Westinghouse
Electric Corporation

DCP/NRC1003
NSD-NRC-97-5289
Docket No.: 52-003

SUBJECT: AP600 RESPONSE TO REQUESTS FOR ADDITIONAL INFORMATION

Enclosed are the Westinghouse responses to NRC requests for additional information related to WCAP-14407, "WGOthic Application to AP600." Responses are provided for the items listed in the attached table. These RAI responses are the second group of RAIs related to information contained in WCAP-14407, Rev. 1, and include the RAI responses related to 2-D conduction which were scheduled to be completed on 8/31/97. The first group of RAI responses related to WCAP-14407, Revision 1 was sent to you via Reference 1.

Figure 4-35 Above-Deck East Steam Generator Room Cross-Section - AA

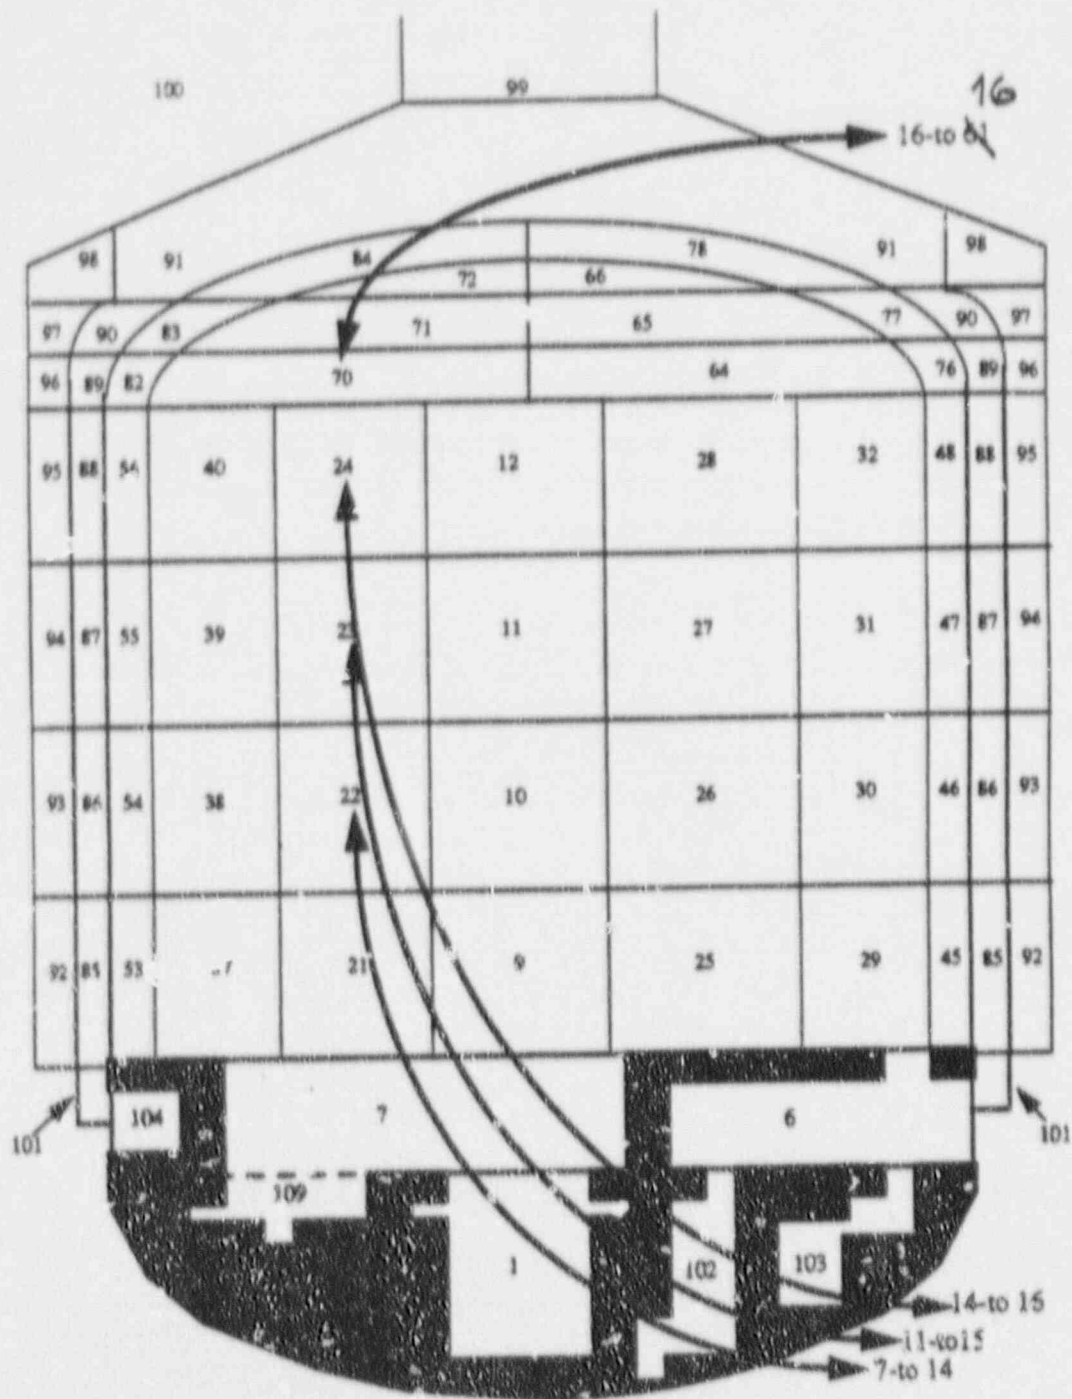
Please clarify the flow paths shown in Figure 4-35. Are the directions of the arrows for cutline AA correct? Explain the notation in Figure 4-35. What does 16-to 16 and 14-to 16, etc., mean?

A typographical error was made in the preparation of Figure 4-35, "Above-Deck East Steam Generator Room Cross-Section -- AA," for WCAP-14407, Rev. 1. The figure incorrectly identifies Volume 70 being connected to Volume 61 by flow path 16; the correct flow path specification is Volume 70 connected to Volume 16 by flow path 16 of Table 4-4 (16-to 16). A marked up copy of Figure 4-35 correcting this error is attached as part of the response to this RAI. A corrected Figure 4-35 will be provided as errata to Revision 1 of WCAP-14407.

Figure 4-35 of WCAP-14407, Rev. 1, has been amended to clarify the flow paths joining nodes. Arrowheads have been added to both ends of the lines depicting flow junctions between pairs of nodes to indicate the possibility of flow in either direction between a pair of coupled nodes.

Figure 4-35 of WCAP-14407, Rev. 1, is an accurate depiction of cutline AA shown in Figure 4-33, "Upper East Steam Generator Room." The flow paths shown in Figure 4-35 are annotated to indicate the flow path number from Column 1 of Table 4-4 and the connecting volume. For example, the flow path from Volume 24 is annotated as "14-to 16" and indicates that Volume 24 is connected to Volume 16 with flow path number 14 from Table 4-4. Three of the pairs of volumes for which flow paths are defined, 24 and 16, 23 and 15, and 22 and 14, are at the same elevation. The remaining pair of volumes, 70 and 16, volume 16 is actually adjacent to but below volume 70. The lines depicting the flow paths between the pairs shown in Figure 4-35 were drawn so as to minimize crossing of numbered nodes in the figure and do not represent the actual elevation of the flow junction and thereby keeping Figure 4-35 easy to read.

Figure 480.778-1 Crane Girder

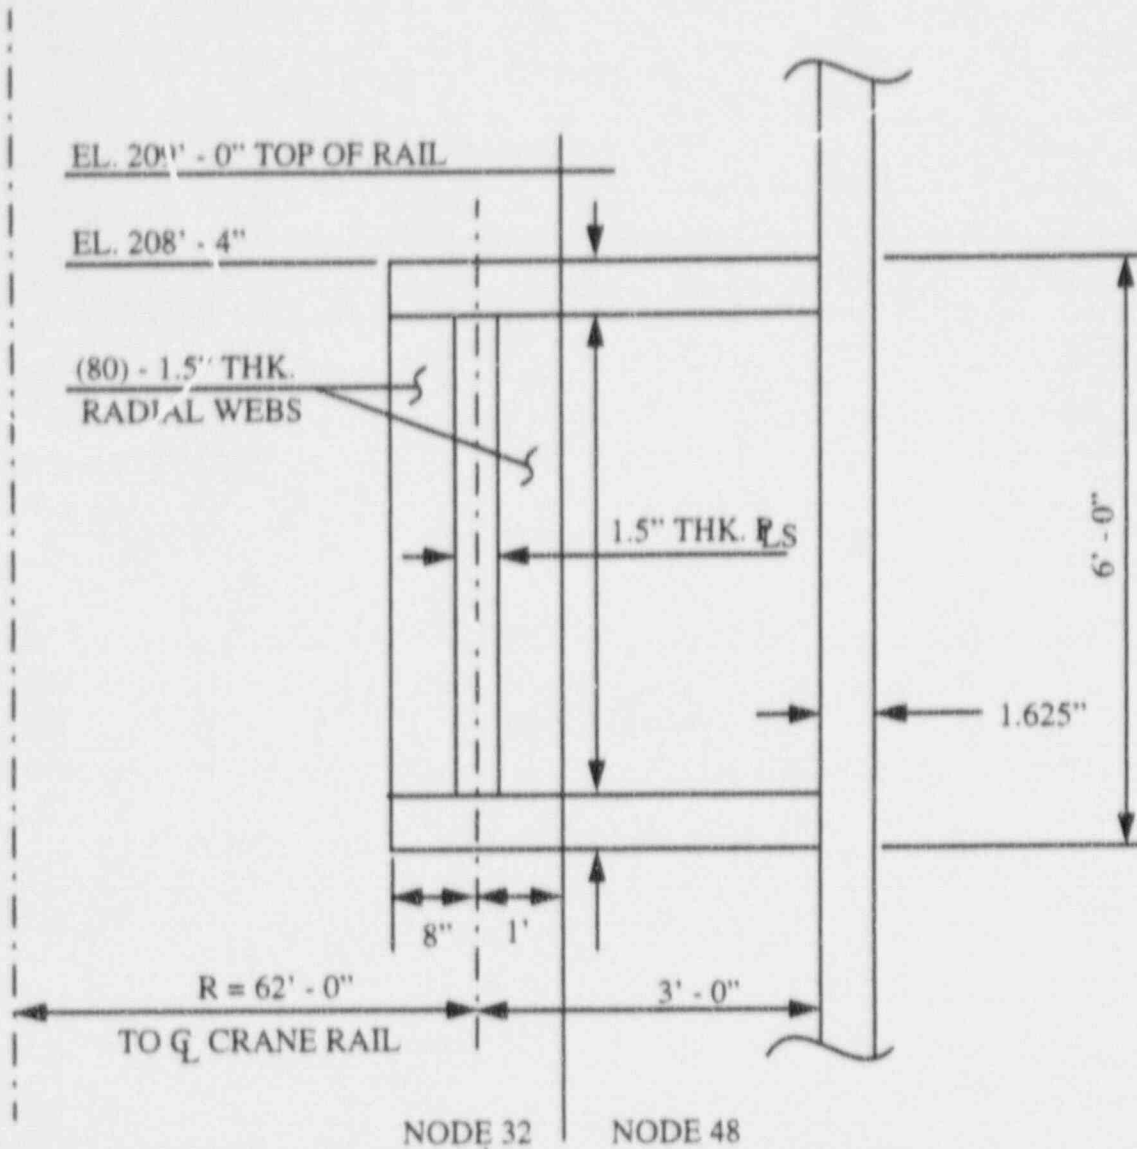
Provide a diagram showing the crane girder, which presents Conductor 10 in Control Volume 32, and show what fraction of the girder is part of Control Volume 32.

The requested diagram, indicating crane girder details and node location, is attached as Figure 480.778-1.

Figure 480.779-1 HVAC Ring Duct

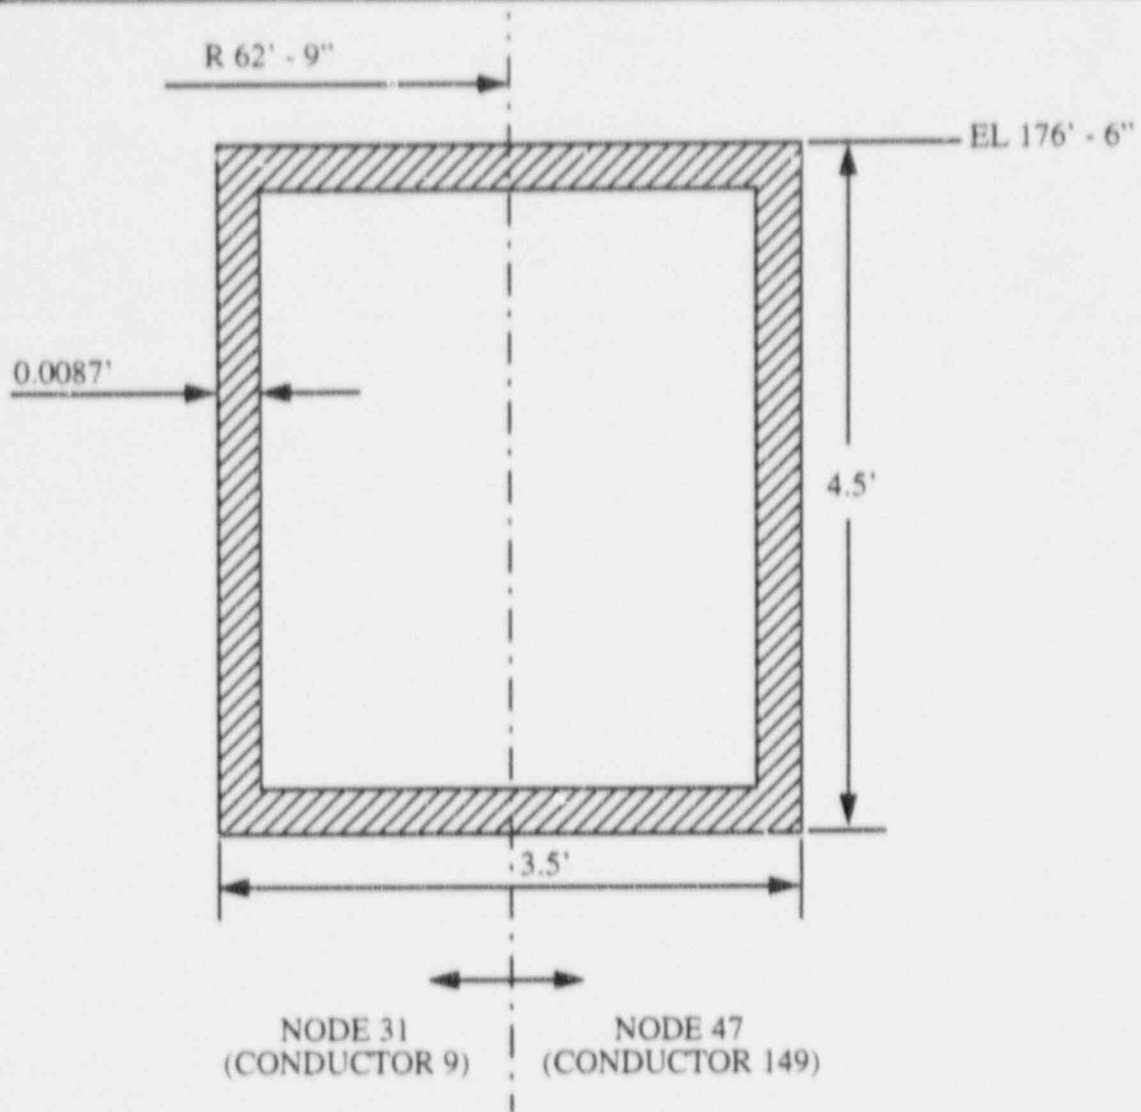
Explain whether the ring duct, Conductor 9, is fully embedded in Control Volume 3 or only a fraction of it. Is there any support structure for the ring duct? Has this been lumped into the conductor type? Provide a diagram.

The calculation of HVAC ring duct geometric properties for modeling as conductor 122 assumes that half of the ring duct (vertical center-line) is contained in node 31 (as conductor 122) and half is contained in node 47 (as conductor 148). Please refer to the accompanying Figure 480.779-1 for additional ring duct details.

Figure 4-61 West Outer Quarter Annulus Cross-Section - BB

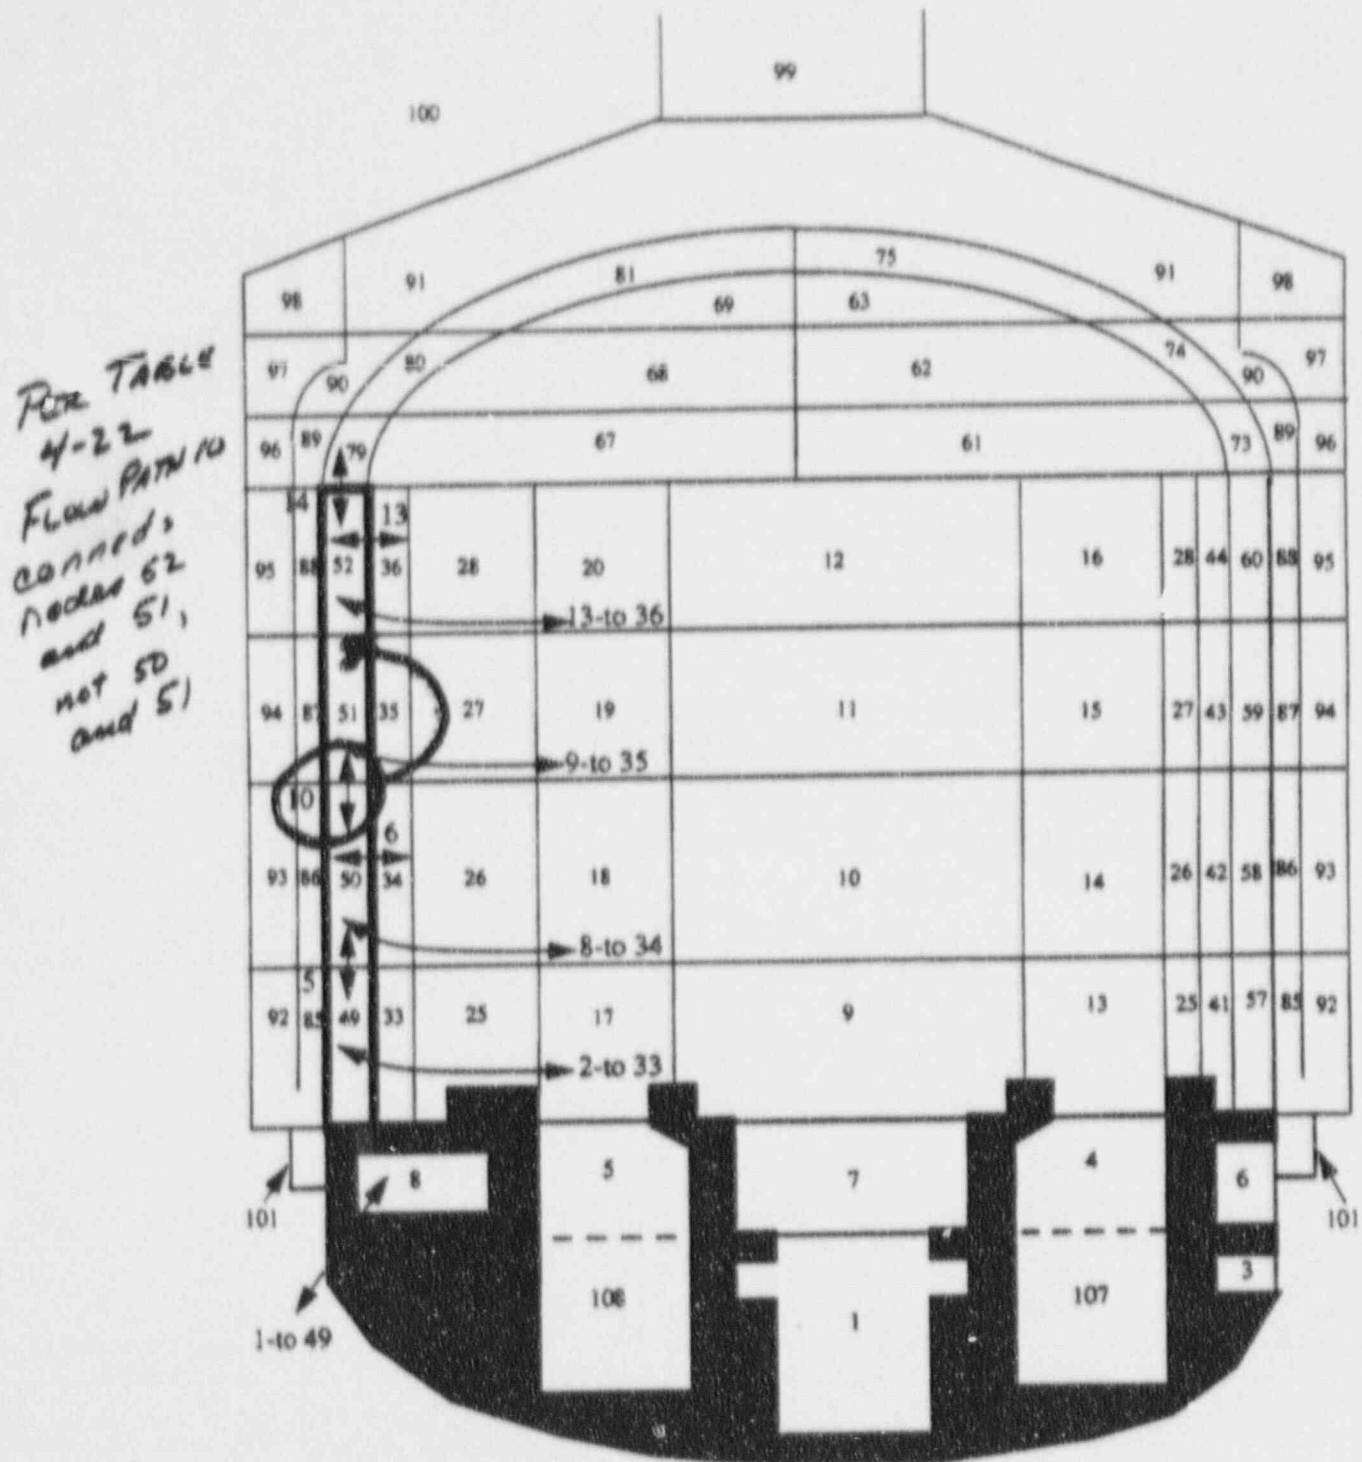
Provide information about Flow Path 1 shown in Figure 4-61. Does this flow path return the containment shell condensate flow to the IRWST? How wide is this condensate return gap?

The flow path arrow 10 between Volumes 50 and 51 in Figure 4-61 of WCAP-14407, Rev. 1 is located incorrectly. Flow path arrow 10 (which represents AP600 Evaluation Model (EM) flow path 135) actually connects Volumes 51 and 52. Due to the presence of the internal stiffener at the 170' -0" elevation, the flow area between Volumes 50 and 51 is completely blocked, and so no vertical flow path exists in the Outer-Quarter Annulus Rooms across the volume boundary at the 170' -0" elevation.

A markup of Figure 4-61 is attached, and shows the correct location of flow path arrow 10. A corrected Figure 4-61 will be issued as an errata to WCAP-14407, Rev. 1.

Table 4-22 of WCAP-14407, Rev. 1 has been expanded to include the two nodes connected by Flow Path 1, as shown in Figure 4-61. Figure 4-61 has also been amended to identify the node from which Flow Path 1 emanates.
